SUBJECT: DEMONSTRATION / DELIVERY HOLD - Safety Recall 16S31 - *Supplement #3*
 Certain 2013-2015 Model Year Flex, MKS, MKT, and Taurus Vehicles Equipped
 With 3.5L Ecoboost Engines, and 2013-2015 Police Interceptor Sedan Vehicles
 Fuel Pump Control Module Inspection and Repair

New! REASON FOR THIS SUPPLEMENT

- *Service Parts: Additional part numbers for repairs under this Safety Recall are available for Taurus, MKS and Police Interceptor Sedan.*

FIGURE 1

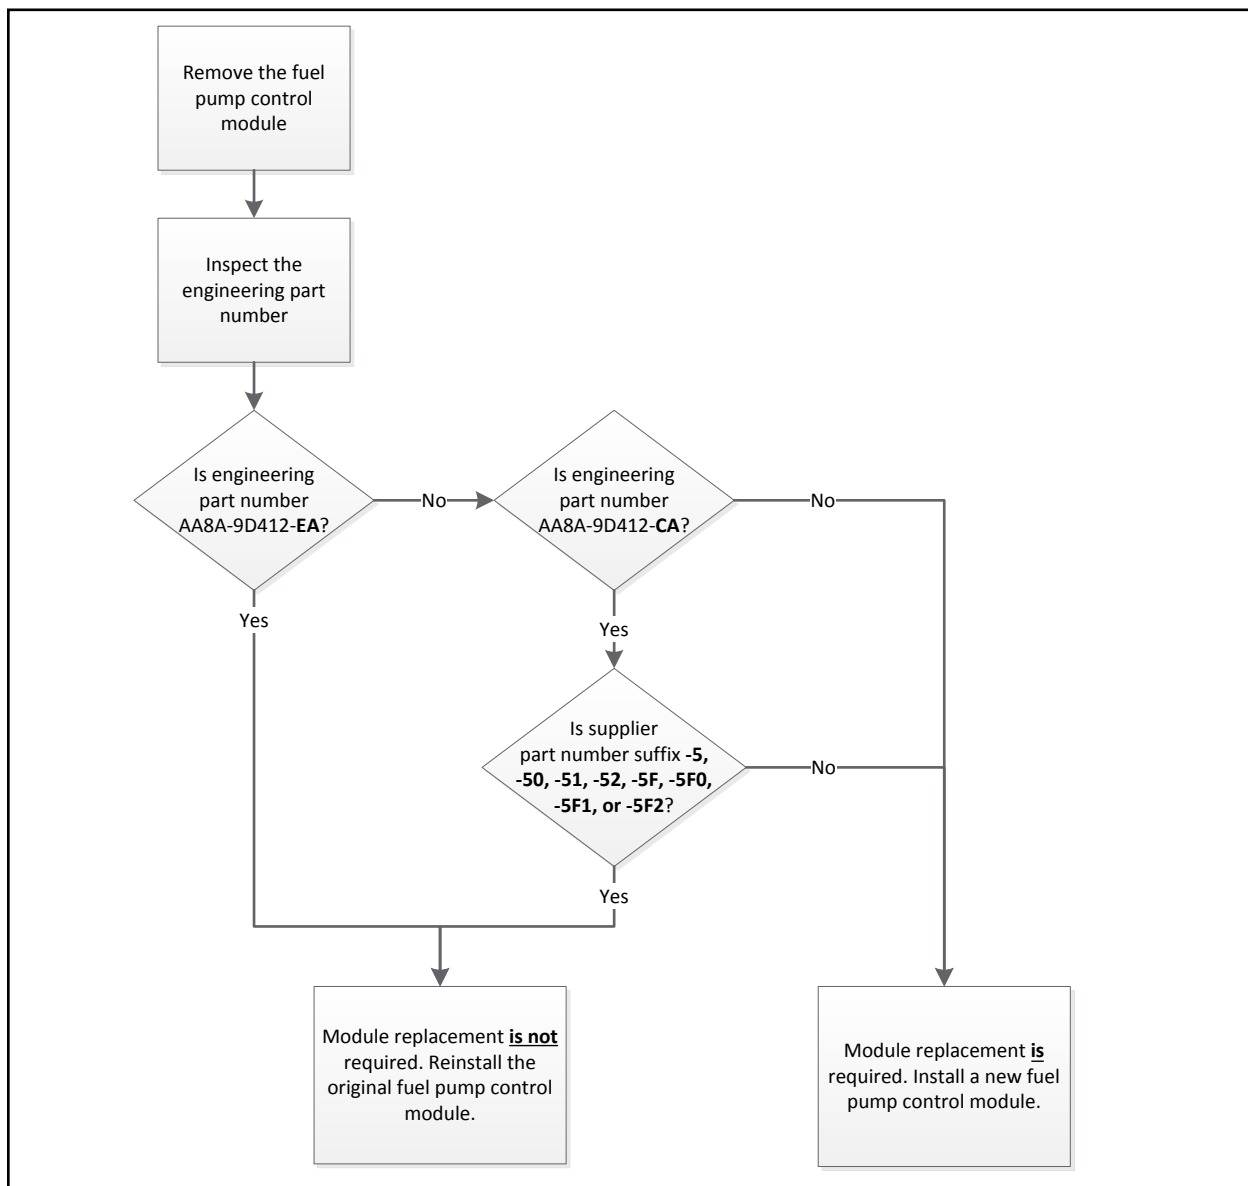
1. Remove the fuel pump control module. Please follow the Workshop Manual (WSM) procedures in Section 303-04.
2. Inspect the engineering part number and, if necessary, the supplier part number suffix on the fuel pump control module. See Figure 1.
 - If either (A) the engineering part number is AA8A-9D412-EA, OR (B) the engineering part number is AA8A-9D412-CA and the supplier part number suffix is -5, -50, -51, -52, -5F, -5F0, -5F1, or -5F2, module replacement is not required. Reinstall the original fuel pump control module. Please follow the WSM procedures in Section 303-04. No additional service is required.
 - If the module does not meet either criteria, proceed to Step 3.
3. *Install a new fuel pump control module. Please follow the WSM procedures in Section 303-04.*

NOTE: *For Flex and MKT, ensure the replacement module meets the above criteria.*

ENGINEERING PART NUMBER AA8A-9D412-EA	ENGINEERING PART NUMBER AA8A-9D412-CA
<ul style="list-style-type: none"> • ALL PARTS OK TO USE 	<ul style="list-style-type: none"> • SUPPLIER SUFFIX -5, -50, -51, -52, -5F, -5F0, -5F1, -5F2 ARE OK TO USE
